Inver Grove Heights Environmental Commission
Thursday, July 25, 2024 at 7:00 PM
8150 Barbara Avenue, Inver Grove Heights, MN 55077

Environmental Advisory Commission Staff Report

SUBJECT: Presentation on Pine Bend Landfill's Vertical Capacity Expansion Request

Veneer Analysis – Long Term Slope Stability

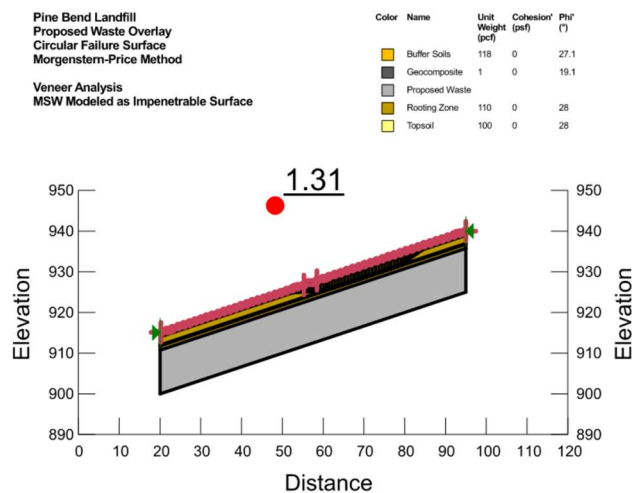
- c. A veneer stability analyses of an isolated segment of the cover system on a 3H:1V slope appears to be absent from the analysis but is required to confirm stability of the proposed cover system.

A veneer stability analysis of an isolated segment of the proposed cover system on a 3H:1V slope was completed using SLOPE/W, a limit equilibrium slope stability analysis software. In the first analysis, all cover components were modeled assuming zero cohesion in the interface strength, except for the liner/geo-composite interface. Interface friction testing shows that cohesion is a component of the strength at this interface, and this should not change based on variations in the soil components of the cover. The MSW waste material was modeled as an impenetrable surface to limit the analysis to the cover components. The program's optimization function was enabled to allow the program to determine if the critical failure surface would closer resemble a circular or block type failure. The resulting factor of safety for this veneer analysis was 1.60, exceeding the desired minimum factor of safety of 1.5 for long term stability.

As a check, a second analysis as performed assuming no cohesion in the liner/geo-composite interface to represent a conservative and short-term case. The resulting factor of safety was 1.31, exceed the desired minimum factor of safety of 1.2 for short-term stability. The outputs for both veneer analyses are shown below.

Noted, recommendation resolved.

Slope Stability Analysis - Phase 2 Waste Impenetrable, With Phase 5/6 Liner Cohesion

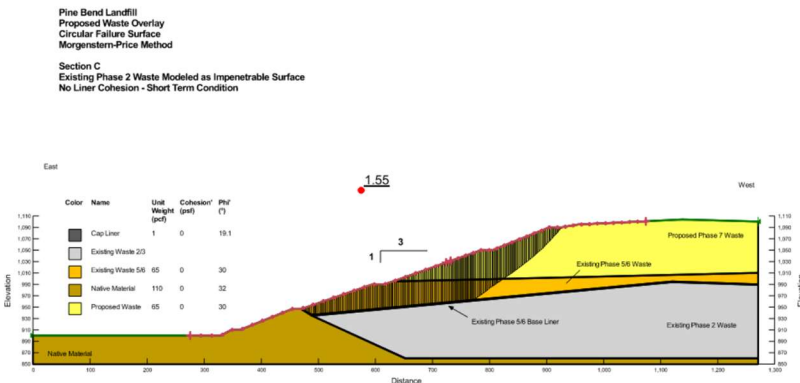
- d. The overall slope stability analysis lacks evaluation of alternate failure surface entry and exit points and does not include analyses that treat the “existing cover liner” as an impenetrable surface. These additional analyses are critical to understanding overall stability of the proposed slope system.

The model was updated to reflect the existing and proposed conditions as illustrated in Section C of the plan set. Analyses were completed to evaluate the proposed overlay slope stability assuming that the existing Phase 2 waste material below the Phase 5/6 liner is an impenetrable surface. This

configuration was modeled assuming no cohesion in the waste or native materials and with and without cohesion on the Phase 5/6 liner. A third analysis considered global slope stability with all layers defined as penetrable and no cohesion strength attributed to any materials. As in the veneer analysis above, the program's optimization function was enabled to allow the program to determine if the critical failure surface would closer resemble a circular or block type failure. In each case, the resulting factor of safety exceeded the desired long-term factor of safety of 1.5. The model outputs are included below for reference.
